City of San Leandro

BANCROFT AVENUE AND 136TH AVENUE TRAFFIC SIGNAL PROJECT NO. 11-150-38-330; STATE PROJECT NO. SR2SL-5041(038)

ADDENDUM NO. 1

December 23, 2011

BANCROFT AVE & 136TH AVE
TRAFFIC SIGNAL
STREET IMPROVEMENT SHEET

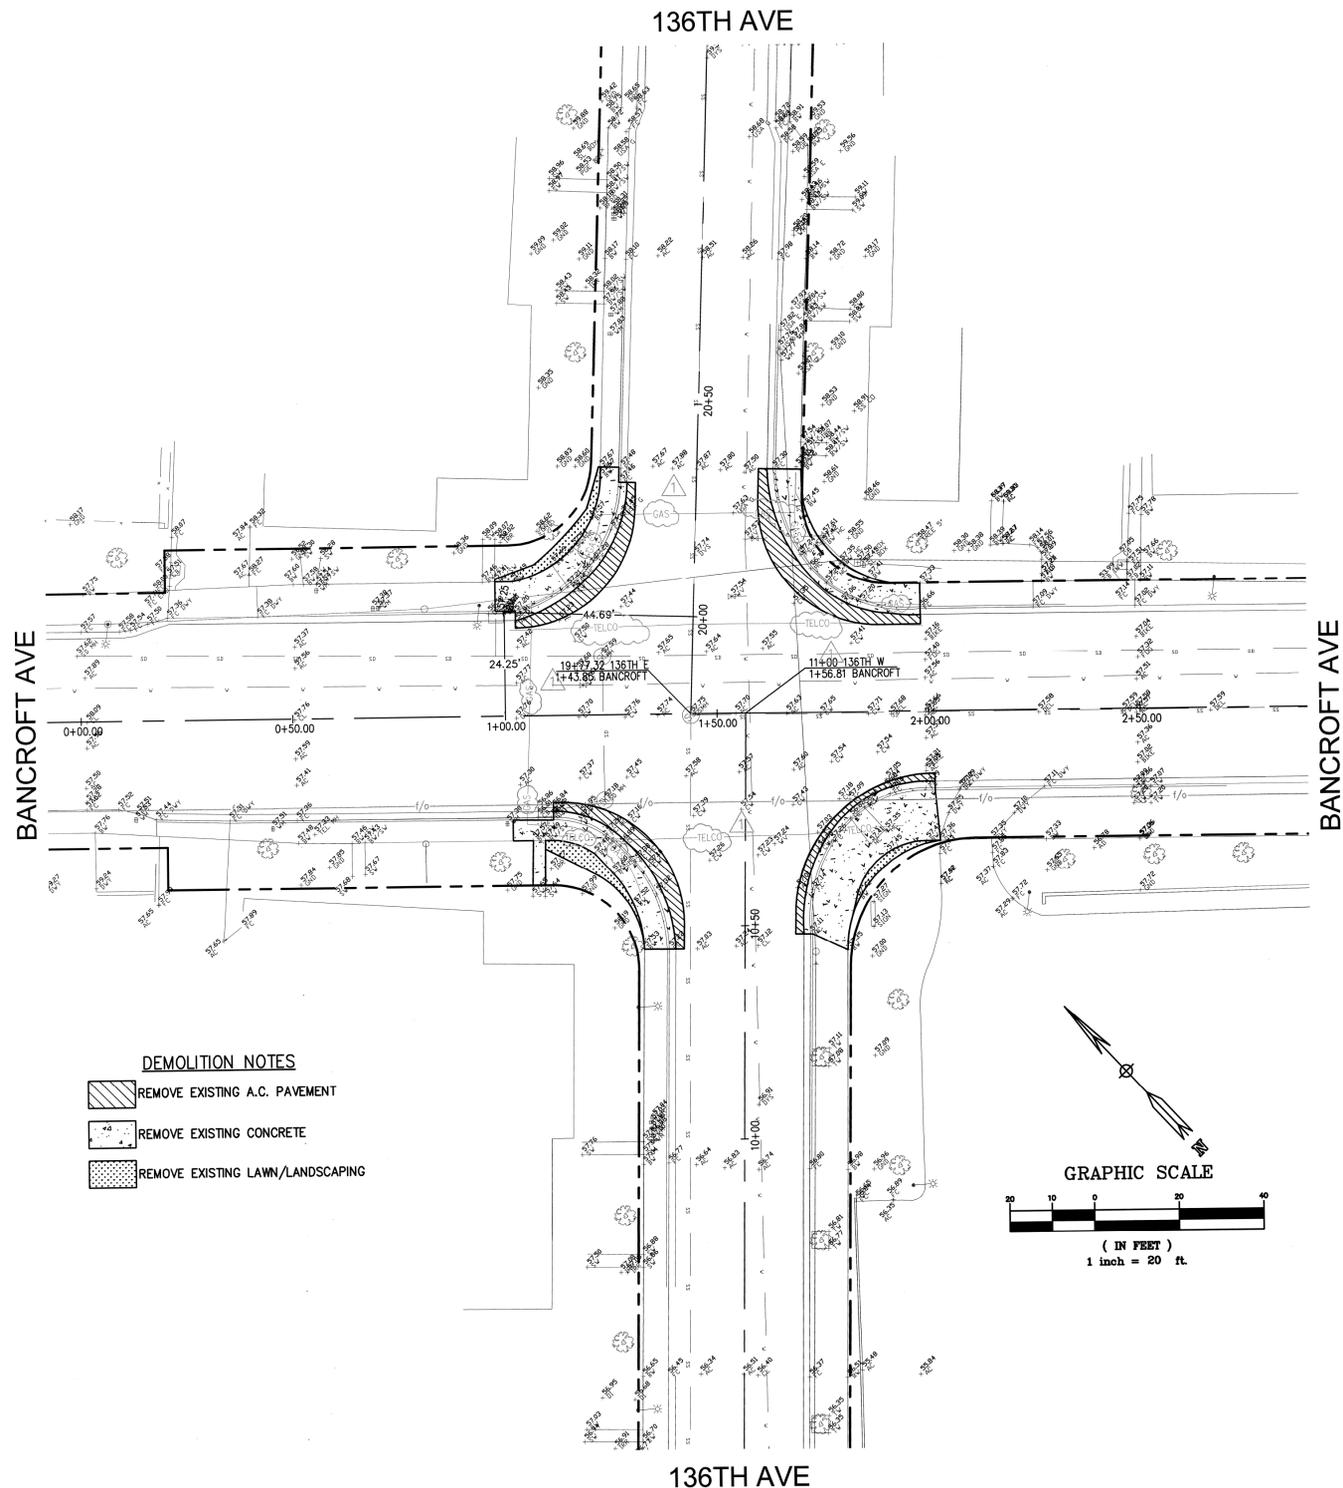
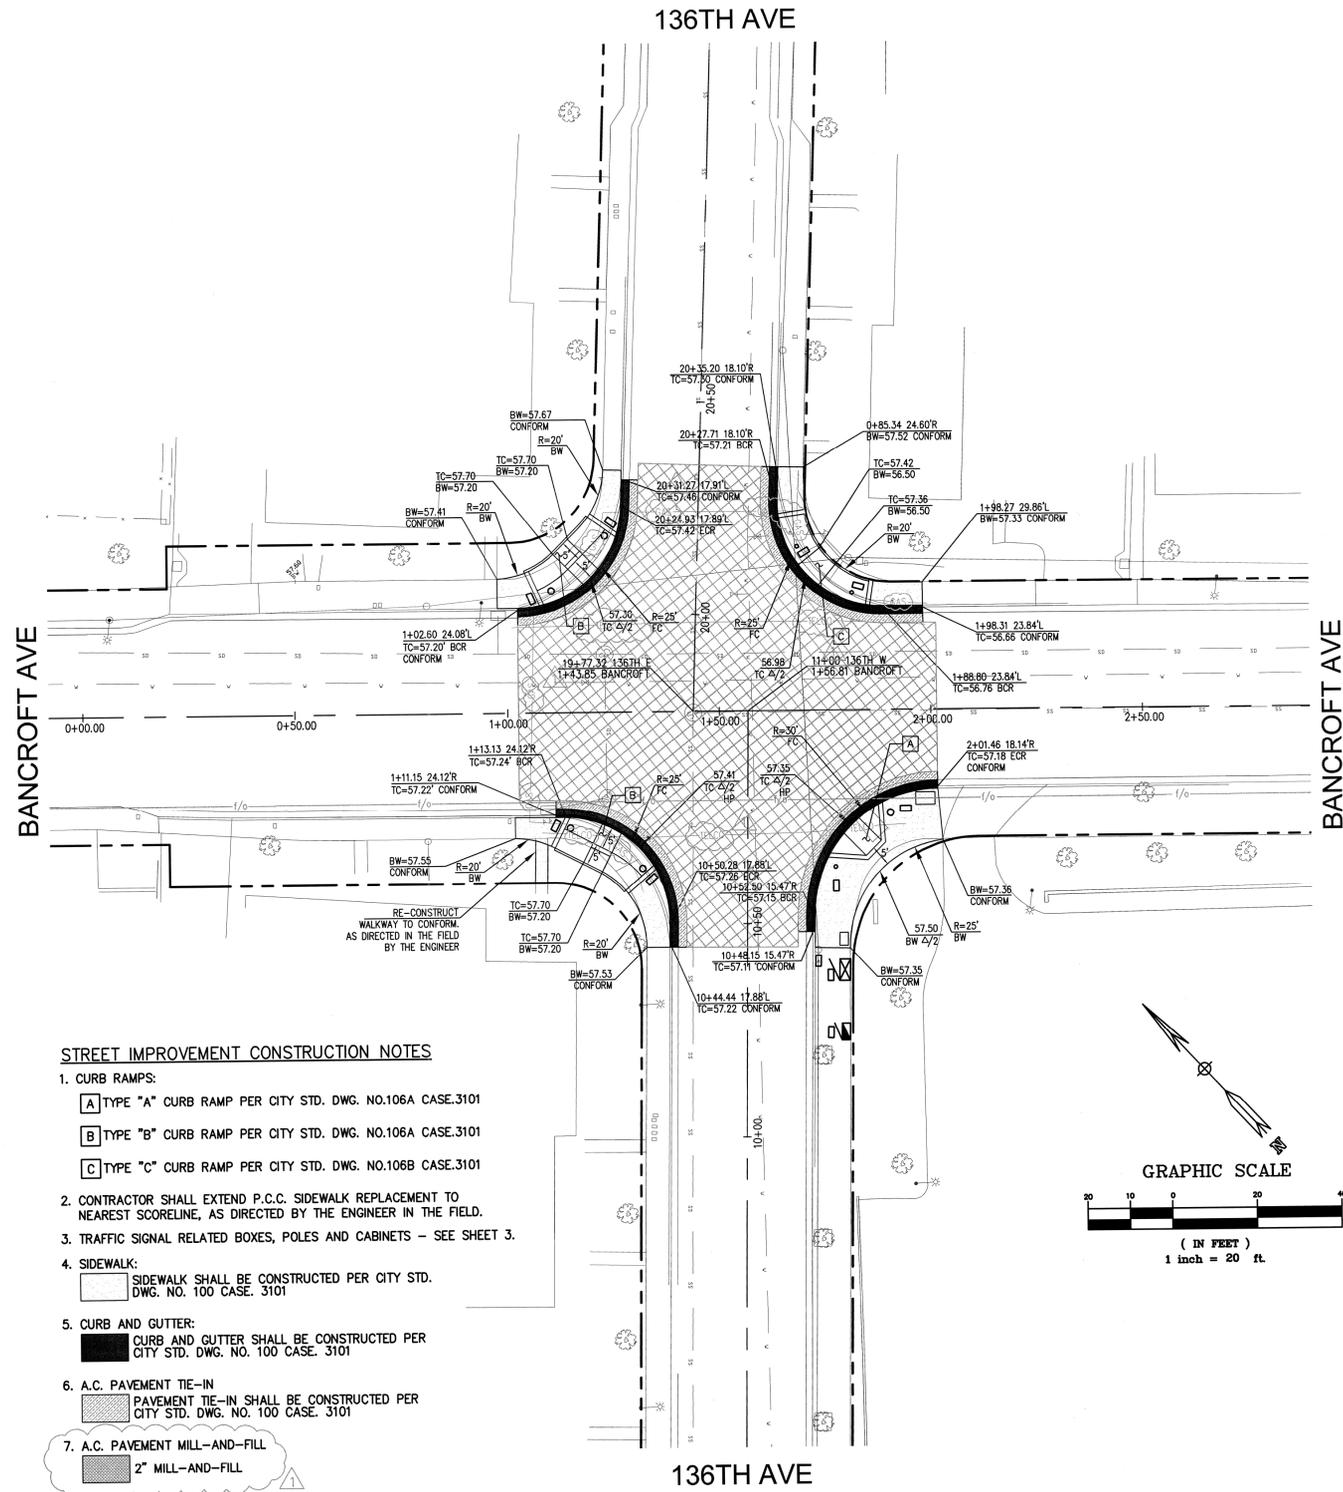
Item 1.17 Drawing Sheet 2, STREET IMPROVEMENT SHEET This sheet is replaced by a revised sheet with the following revisions.

1. Included approximate locations for existing underground gas lines, and telephone ducts.
2. Mill-and-Fill limit of work and notes.

TRAFFIC SIGNAL INSTALLATION SHEET

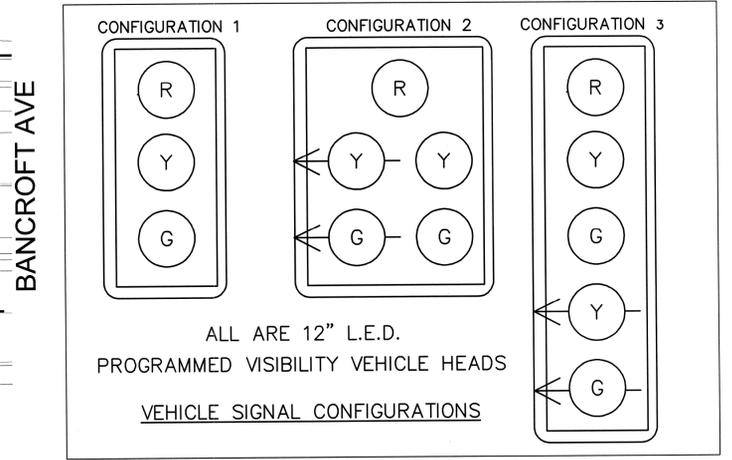
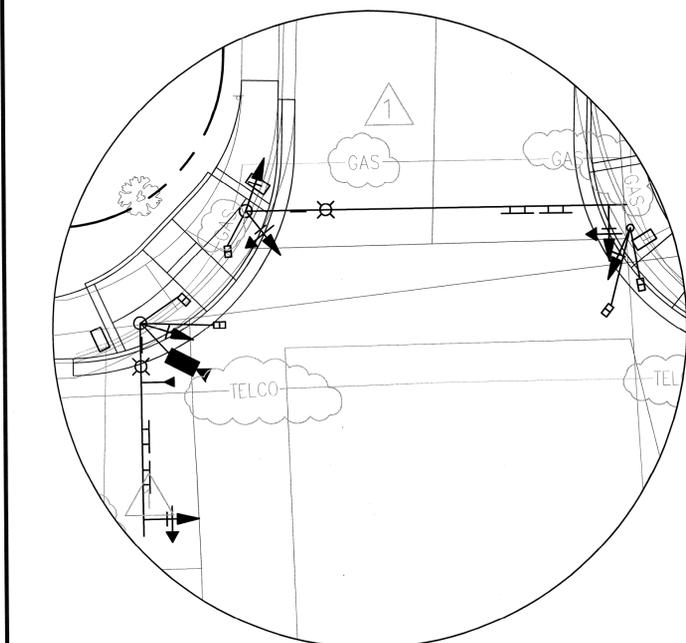
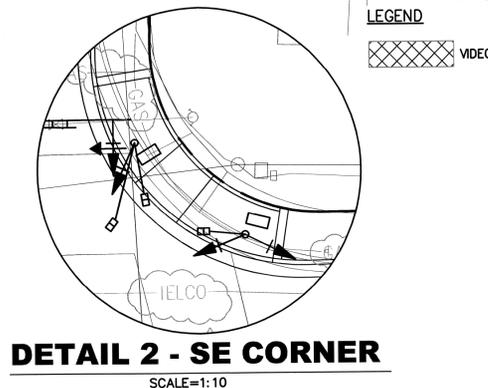
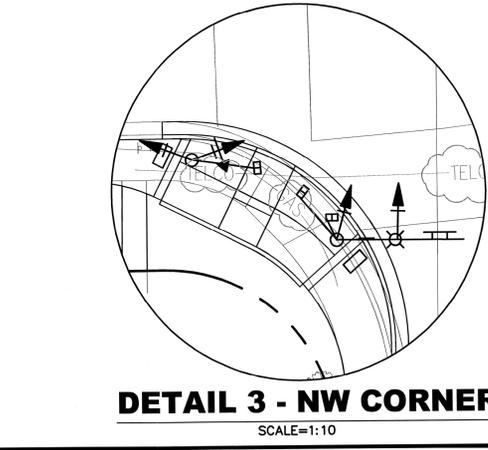
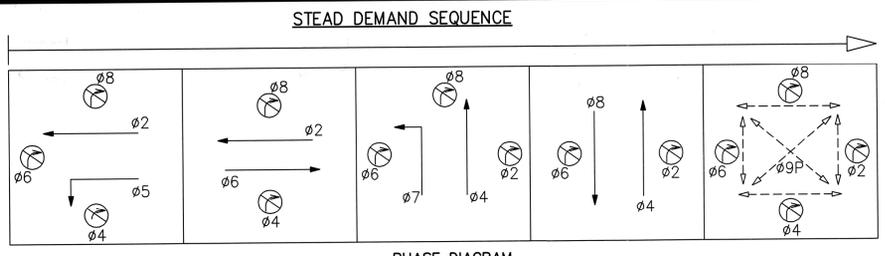
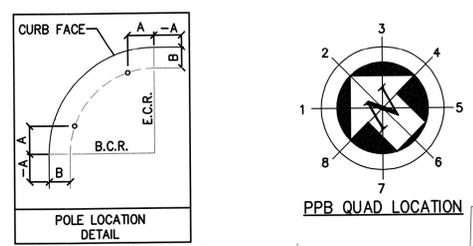
Item 1.18 Drawing Sheet 3, TRAFFIC SIGNAL INSTALLATION SHEET This sheet is replaced by a revised sheet with the following revisions.

1. Included approximate locations for existing underground gas lines, and telephone ducts.
2. Revised Traffic Signal Construction Notes
